March 3, 2026

Rainforth Grau Architects Project No. 2022-1545.00
PTN: 68585-238

ADDENDUM NO. 1

Henderson Elementary School - Lunch Shelter
Lodi, California
Lodi Unified School District

PROJECT NO. 22-1545
DATE: 1/21/26
SHEET
A1.1.2
AD 1.01

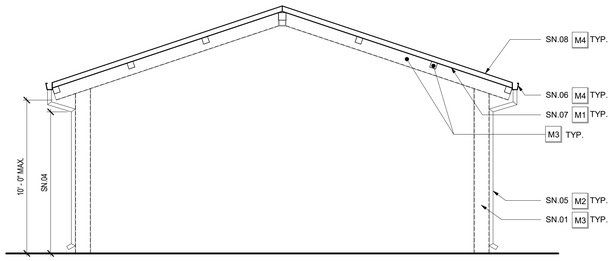
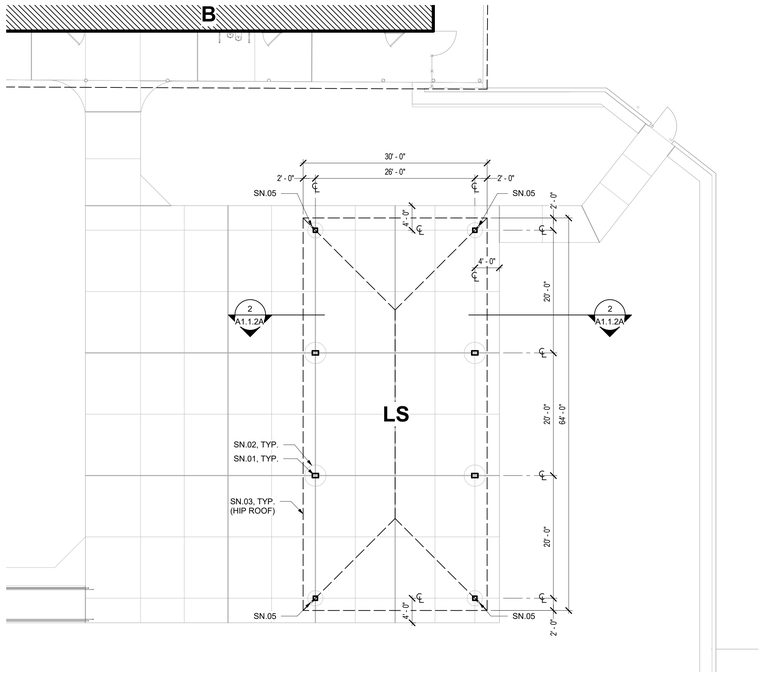
B. Sheet A1.1.2, Lunch Shelter Exhibit
      1. ADD Sheet AD 1.01 included with this addendum.
   C. Sheet A2.1.1, Enlarged Floor Plans and Fixture Schedule
